## Public Comment No. 1653-NFPA 70-2024 [ Global Input ]

This Global Public Comment is for CMP-13 to review the use of the terms “overcurrent”, “overcurrent protective devices” and “overcurrent protection”.

**CMP-10 TG-4 Review of Overcurrent Language for the Articles under the purview of CMP-13**

# Temporary Source of Power 700.3(F)

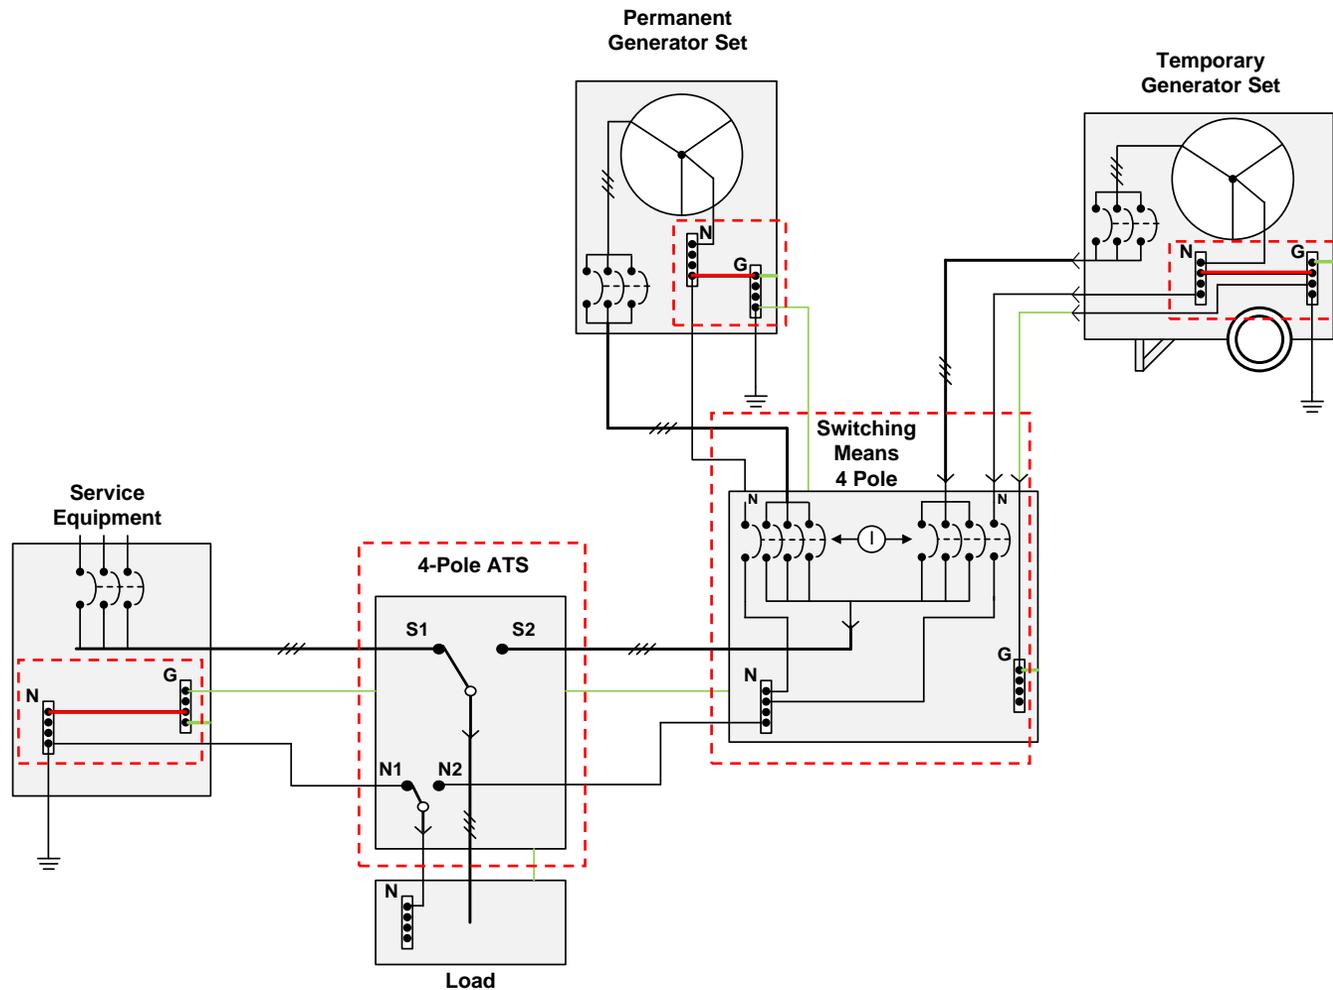
- Neutral to Ground Bonding Jumper at Service Equipment
- Neutral to Ground Bonding Jumper at Permanent Generator
- 4-Pole ATS
- 4-Pole Switching Means
- When Temporary Genset is used, Neutral to Ground Bonding Jumper at Temporary Genset

# Temporary Source of Power 700.3(F)

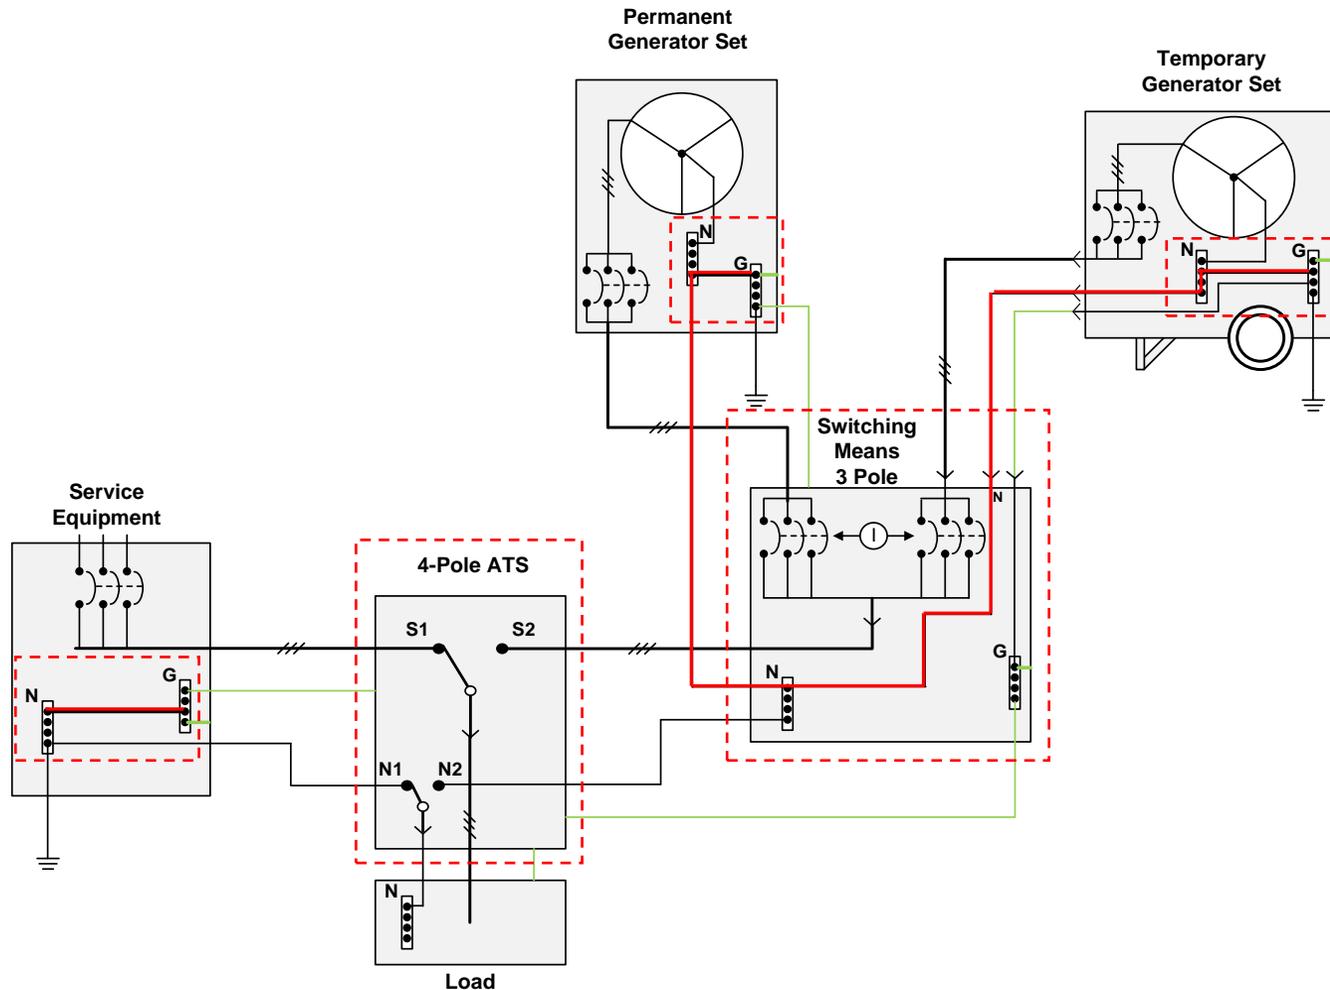
- Neutral to Ground Bonding Jumper at Service Equipment
- Neutral to Ground Bonding Jumper at Permanent Generator
- 4-Pole ATS
- **3-Pole Switching Means**
- When Temporary Genset is used, Neutral to Ground Bonding Jumper at Temporary Genset
- **Multiple or No Neutral Bonding Jumper on Generators (Multiple Jumpers Shown).**

**Figure Informational Note 700.32 Emergency System Selective Coordination.**

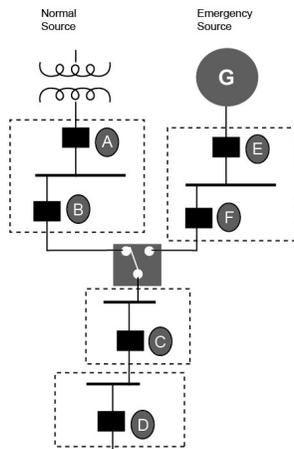
OCPD F selectively coordinates with OCPD E.

OCPD B is not required to selectively coordinate with OCPD A because OCPD B is not an emergency system OCPD.

**Figure 1**

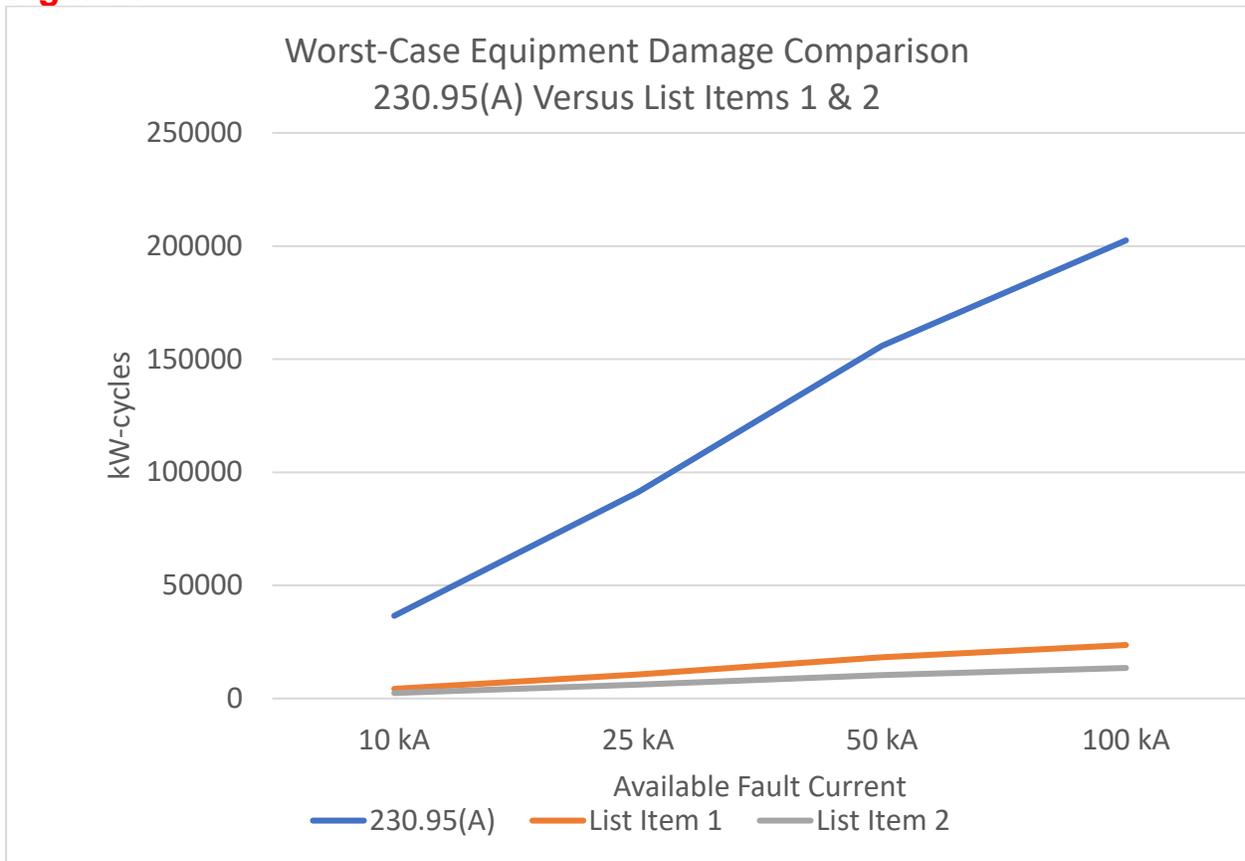
The IEEE 1584-2018 minimum arcing current is 6.09kA. Using the maximum 230.95(A) opening time of 60 cycles, the equipment damage is (6.09 kA X 60 cycles X 100 arcing volts) = 36,540 kW-cycles. See Figure 1.

The IEEE 1584-2018 minimum arcing current is 6.09kA. Assuming an opening time of 4 cycles for 240.87(B)(1), (B)(2), or (B)(4), the equipment damage is (6.09 kA X 4.0 cycles X 100 arcing volts) = 2,436 kW-cycles. Assuming an opening time of 3 cycles for 240.87(B)(5) or (B)(6), the equipment damage is (6.09 kA X 3 cycles X 100 arcing volts) = 1,827 kW-cycles. Worst-case damage for the minimum arcing current with this exception for circuit breakers (2,426 KW-Cycles) is less than 7% of the worst-case damage allowed by 230.95(A) (36,540 kW-cycles). See Figure 1.

Figure 1 shows that equipment damage allowed by this Public Comment is always, from 10,000 amperes available through 100,000 amperes available, just a small fraction of the equipment damage allowed by 230.95(A).

**Committee Action:** Rejected  
**Resolution:** The requirements related to ground-fault protection of equipment are better suited to be in section 230.95. 230.95 sets the base requirement for the code.
